SUP 21-01 – (Thales) Wait Avenue Subdivision – 1st Submittal review cycle

Project: SUP 21-01, Thales– Wait Avenue

Subject: Special Use Permit Review Comments

WAIT AVE. & AVERETTE RD.
P.U.D. MASTERPLAN

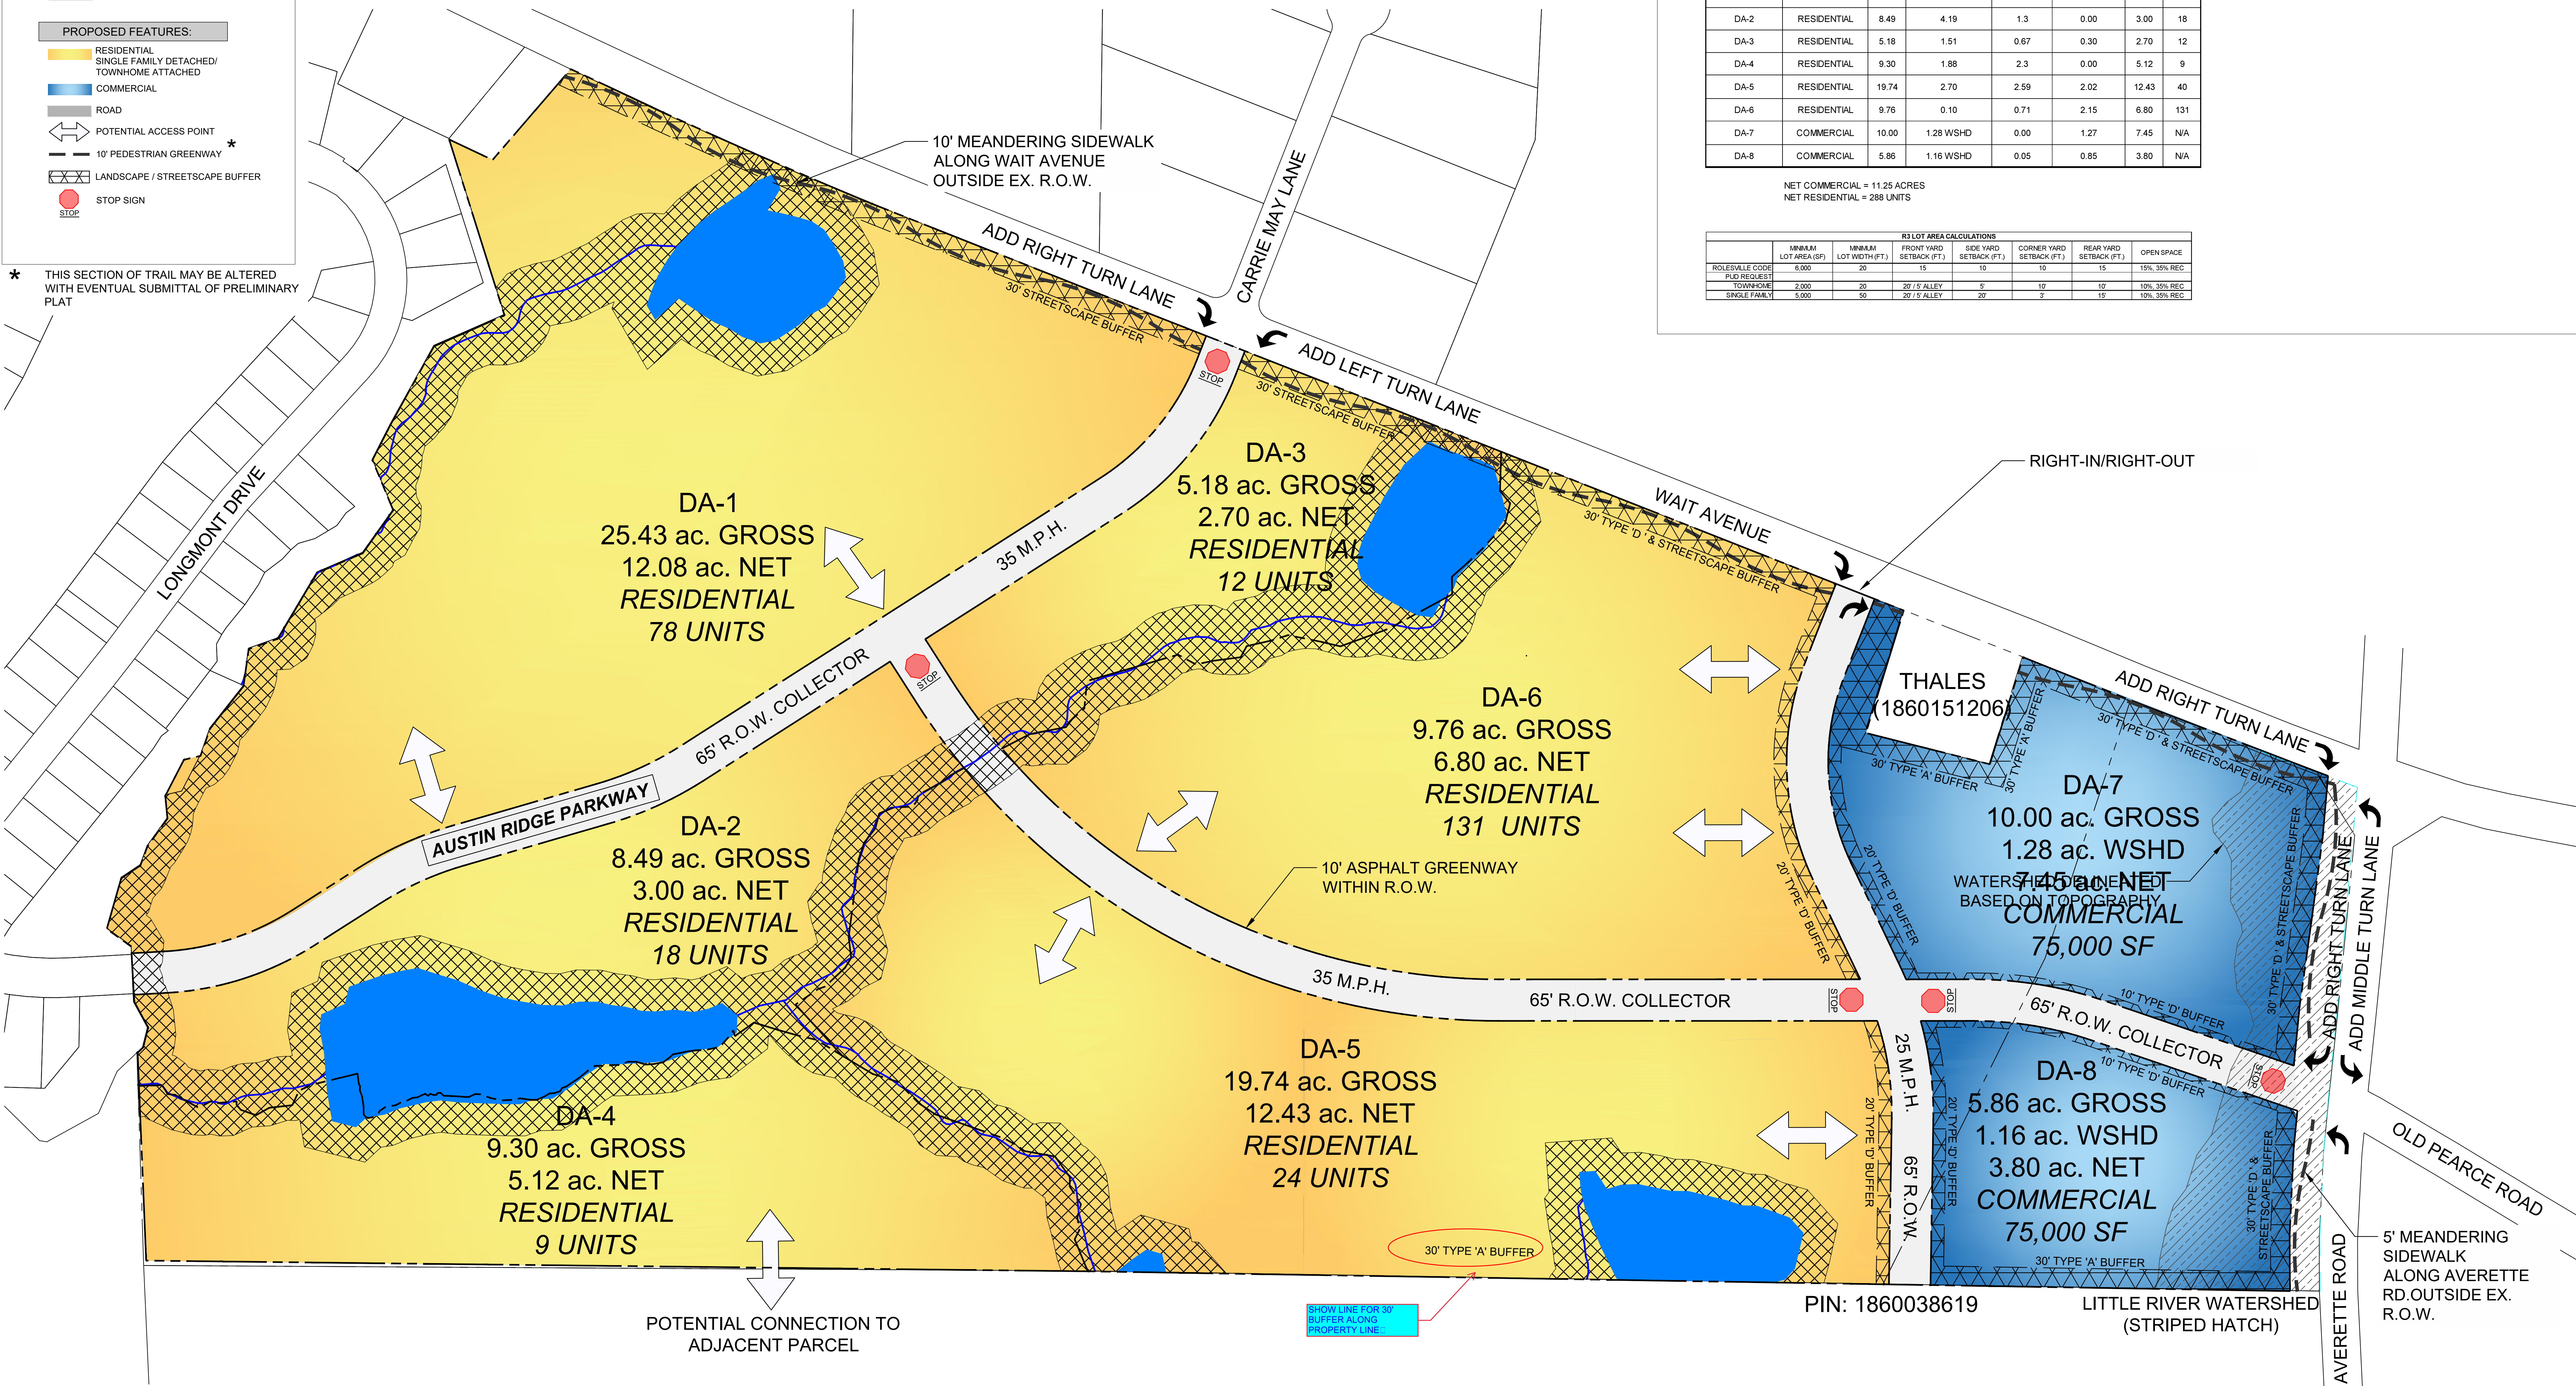
1. The Plan shows Area DA-5 with 24 residential units, but the Calculations Chart shows DA-5 with 40 units.

2. The Master Plan indicates specific number of units in each development area. However, the most recent Preliminary Plat submittal shows a different number of units in the development areas (eg. DA4 indicates 9 units on the Master Plan but the Preliminary Plat shows 10; DA-5 indicates 24 units on the Master Plan but 42 on the Preliminary Plat.)
3. The R3 Lot Area Calculations are incorrect for item listed under Rolesville Code. The Code does not require a 10' Side OR 10' Corner Yard Setback for the R3 Use.
